Re: **Public Meeting September 22, 2021**  
**Clair-Maltby 11.3 Draft Secondary Plan**  
**Final Draft for Community Engagement June 16, 2021**

I am the planning consultant providing these comments on behalf of Timberworks Custom Homes Inc. the owner of 344 and 376 Maltby Road East located in the southeast portion of the Clair-Maltby Secondary Plan. For reference, I have included an excerpt below showing the subject property from Schedule B – Land Use Plan (DRAFT) found on page 50 of the Draft Secondary Plan.

**Schedule B – Land Use Plan (DRAFT)**

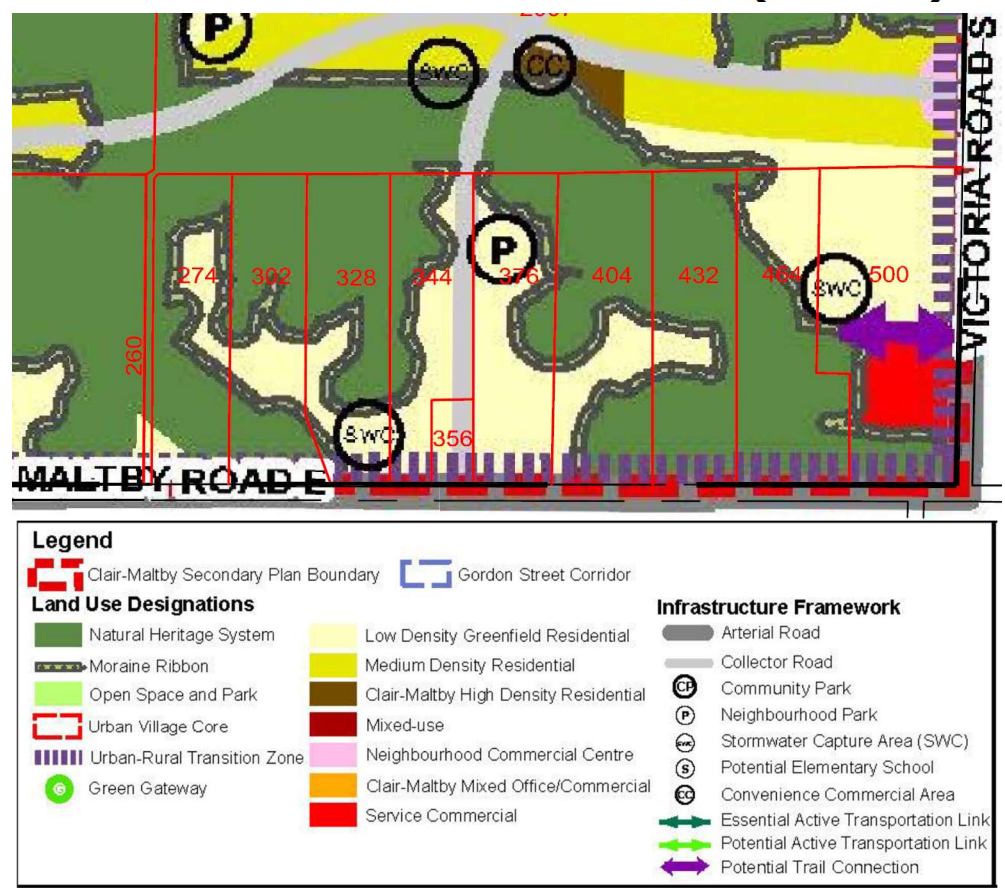
With respect to the **moraine ribbon** shown in the Draft Clair-Maltby mapping, this feature is neither a required environmental element since the Natural Heritage System features and buffers are already identified and protected within the current Official Plan designation, nor is it clearly parkland dedication in the draft secondary plan policies. The moraine ribbon may be included as trails and parkland and if this is the case it should be included in the required parkland dedication requirement and be clearly articulated in the policies. Unfortunately, the moraine ribbon is not located where there are pedestrian and cycling desire lines of travel. The moraine ribbon proposal will result in land needed to provide housing and other uses within the urban area not being available. Approximately 46% of the Clair-Maltby secondary plan area is protected as part of the Natural Heritage System. In addition, there will be schools, parks, stormwater management areas and newly proposed stormwater management overflow areas, and roads which will all reduce the land available for housing and other urban land uses. The moraine ribbon should not be included within the secondary plan. Instead, there should be a policy to accept a percentage of the trail connections as part of the required parkland dedication received by the City.

The need for the proposed north south **collector road** which would proceed to run north through the Rolling Hills neighbourhood (now removed from the Clair-Maltby Secondary Plan Area) is questioned. A collector road is not required in this location since it will not connect Clair Road and Maltby Road. A local road is more appropriate in this location.

The Clair-Maltby Secondary Plan and policies have identified the objective of locating **Neighbourhood Parks** next to Stormwater Capture Areas. This has been consistently applied with the exception of this location. This portion of the Clair-Maltby Secondary Plan is a small isolated area which would not contribute adequately to the need for a Neighbourhood Park. Given the configuration of the natural heritage system in this area much of the land proposed to be designated as Low Density Greenfield Residential will be challenging to access and service to provide housing. The proposed Urban-Rural Transition Zone along Maltby Road further reduces the potential to provide housing within this area. A Neighbourhood Park should, therefore, not be identified within this area.

The **Urban-Rural Transition Zone** which proposes to restrict building heights to 3 storeys should be considered in the context of the land use designations within the abutting Township of Puslinch. Where there are Recreational Lands (golf course) or Greenlands and Core Greenlands designations within the Township of Puslinch, the Urban-Rural Transition should not be required. This will provide opportunities for higher residential densities to be designated abutting Maltby Road and Victoria Road South within the Clair-Maltby Secondary Plan.

## Comprehensive Environmental Impact Study Phase 3 Impact Assessment and Management Plan - Map NH-14B

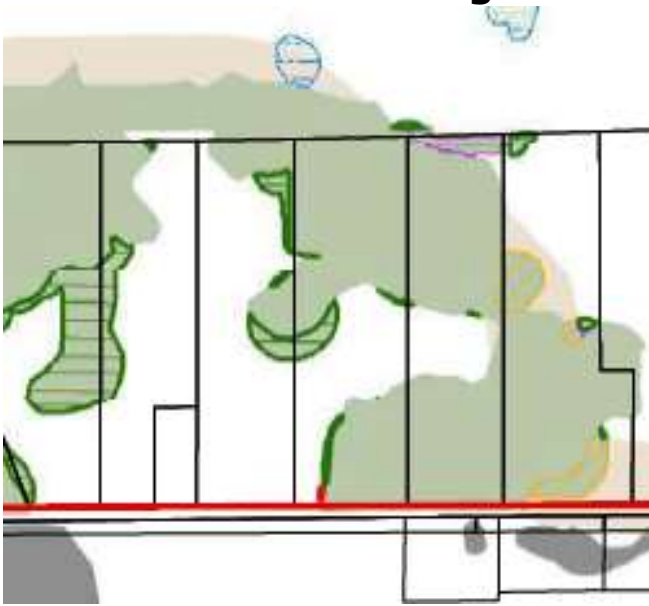
Landowners were advised by the City that OPA No. 42 needed to be completed prior to the Clair-Maltby Secondary Plan to ensure that the natural heritage system was in place prior to the secondary plan process commencing. The **Comprehensive Environmental Impact Study** for the Clair-Maltby Secondary Plan (see excerpt provided) now proposes to include additional Significant Natural Areas. I understand that the technical work required has not been completed to justify the inclusion of these new lands into the natural heritage system. These new "Natural Heritage System Refinements" additions should be removed from the Clair-Maltby Secondary Plan mapping and instead the future Environmental Impact Studies prepared in support of the future planning application should evaluate these areas.
